ATTACHMENT B

MARKED-UP TECHNICAL SPECIFICATIONS

<u>Remove Page</u>	<u>Insert Page</u>
3/4 3-27	3/4 3-27
3/4 8-3	3/4 8-3
3/4 8-4	3/4 8-4
3/4 8-5	3/4 8-5
B 3/4 3-1a	B 3/4 3-1a
B 3/4 8-2	B 3/4 8-2

DIABLO CANYON - UNITS 1 & 2

3/4 3-27

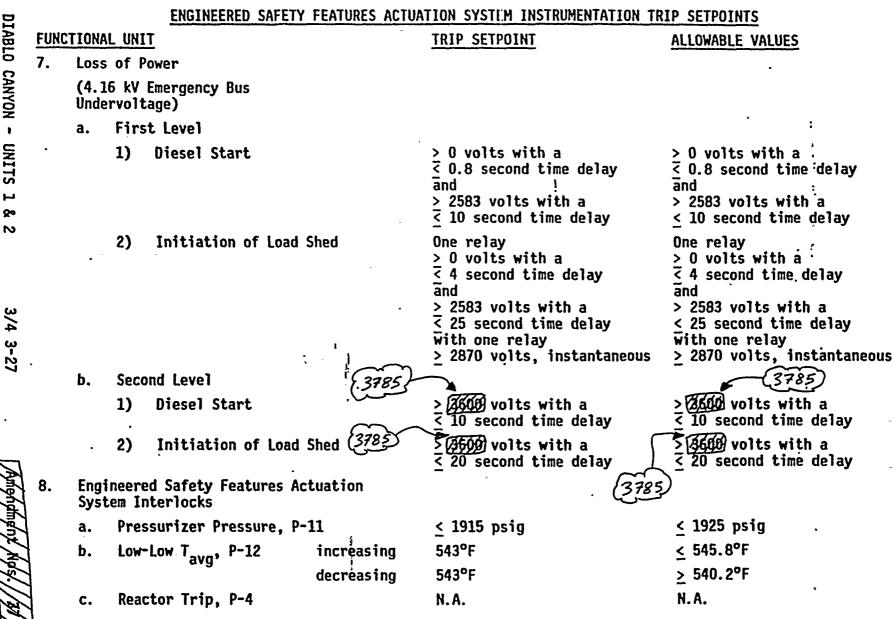
TABLE 3.3-4 (Continued)
